Access Compliance Report

Public Rights-of-Way

(Curb Ramps)

Intersection ID: 10033935	Main Street: PARK_RD	Cross Street: N/A	Location: NW
ADA ID: 8822CB9646E1	Ramp Type: PerpDiag	Initial Pass/Fail: Fail	Overall Compliance: No
		Severity Score: 25

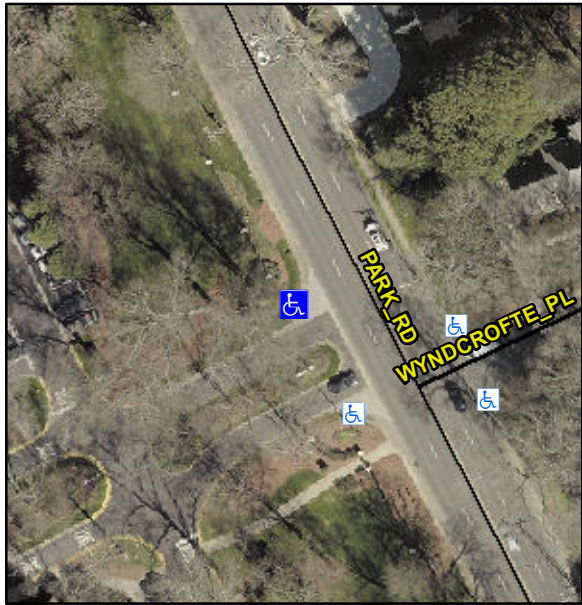
Codes/Mitigation Info/Possible Solution			Field Measurements/Component Compliance					
	Possible Solutions:		Compliance	Description	Data	Compliance	Description	Data
	Remove & Replace Curb Ramp With Two New Directional Ramps or Equivalent.		N/A	Ramp Length (in)	54.0	No	Ramp Slope (%)	10.7
			Yes	Ramp Width (in)	48.0	No	Ramp XSlope (%)	5.8
			N/A	Flare Type LT	N/A	N/A	Flare Type RT	N/A
			N/A	Flare Slope LT (%)	N/A	N/A	Flare Slope RT (%)	N/A
			N/A	Flare Traversable LT?	N/A	N/A	Flare Traversable RT?	N/A
			N/A	Landing Length (in)	N/A	N/A	DWS Provided?	N/A
			N/A	Landing Width (in)	N/A	N/A	DWS Contrast?	N/A
			N/A	Landing Slope (%)	N/A	N/A	DWS Length (in)	N/A
			N/A	Landing X Slope (%)	N/A	N/A	DWS Full Width?	N/A
Surveyor Notes:		N/A	N/A	Landing Curb? (Y/N)	N/A	N/A	DWS Offset (in)	N/A
PROW/ADA:			N/A	Shared Landing?	N/A			
R304.2.2, R304.5.3			N/A	Gutter Ponding?	N/A	N/A	Gutter Slope (%)	N/A
			N/A	Gutter Lip Ht (in)	N/A	N/A	Gutter X Slope (%)	N/A

N/A	Painted X Walk1?	No	N/A	Painted X Walk2?	No
				X Walk 1 Direction	To SE		X Walk 2 Direction	To E
			N/A	X Walk 1 Width (in)	N/A	N/A	X Walk 2 Width (in)	N/A
				X Walk 1 Slope (%)	1.0		X Walk 2 Slope (%)	2.8
				X Walk 1 X Slope (%)	5.2		X Walk 2 X Slope (%)	1.5
Street 1 Name		ENTRANCE	N/A	Ramp inside XWalk1?	N/A	N/A	Ramp inside XWalk2?	N/A
Stop Condition-Street 2		StopSign		Road Slope (%)	4.1	N/A	Clear Space?	N/A
Street 2 Name		PARK RD		Road X Slope (%)	1.1	N/A	Clear Space to XWalk (in)	N/A
Stop Condition-Street 1		None	N/A	Any Obstructions?	N/A	N/A	Storm Grate/Utility Hazard?	N/A
				Obstruction Type			Storm Grate/Utility Type	
						N/A		N/A
						Yes	Surface Condition? (G/P)	Good
Total Cost:		\$ 3200.00
